To: Kristopher Byrd, Well Construction and Compliance Section Manager
From: Joel Jeffery, Well Construction Program Coordinator
Subject: Review of Water Right Application G-18529
Date: August 7, 2018

Groundwater Application Review Summary Form

Application # G- 18529

PUBLIC INTEREST REVIEW FOR GROUNDWATER APPLICATIONS

Figure 3. Water-Level Trends in Nearby Wells

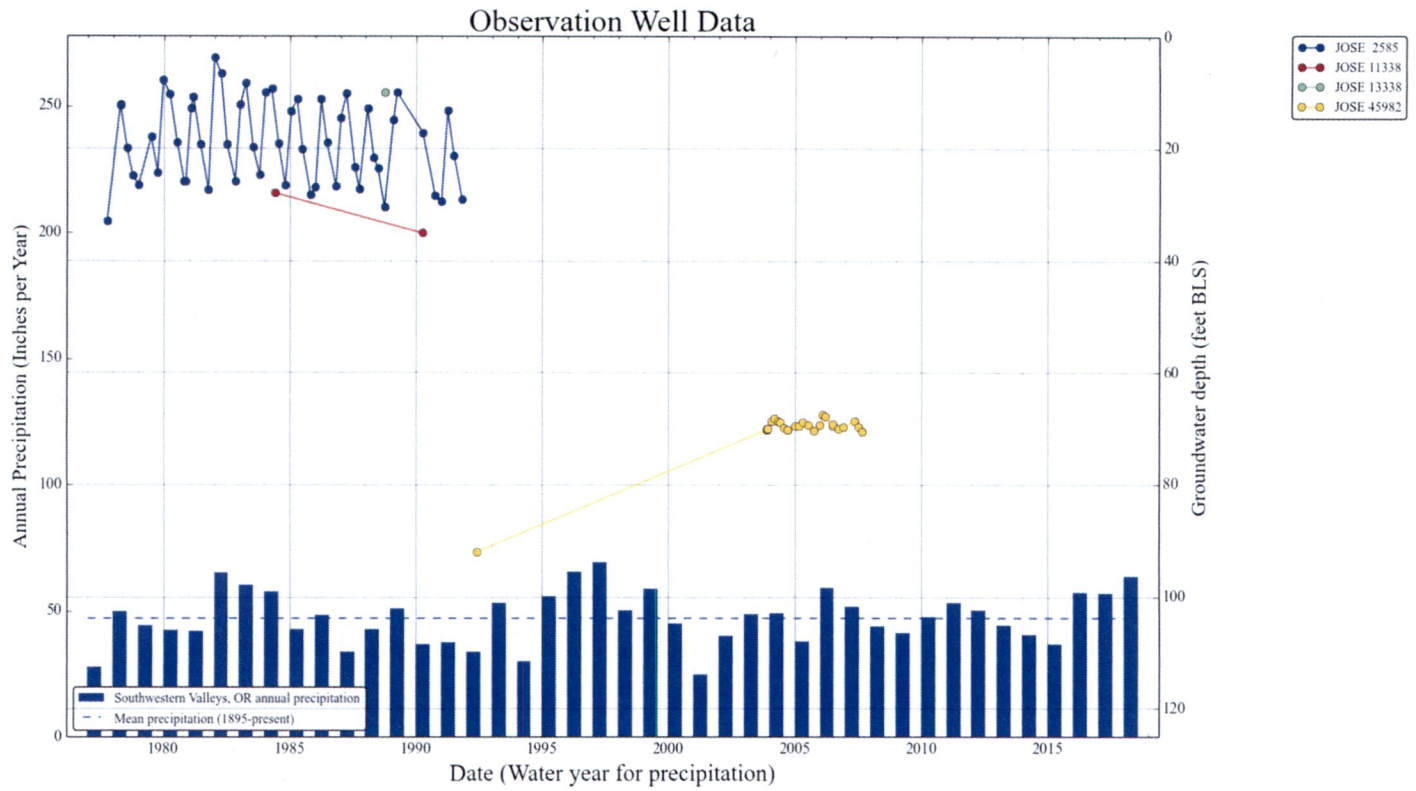
- B3. **Groundwater availability remarks:** There are few current OWRD observation well data within 1 mile of the proposed POA. Two wells indicate previously stable water levels (see Figure 3) but cannot confirm current conditions. As a result, aquifer over-appropriation cannot be determined.
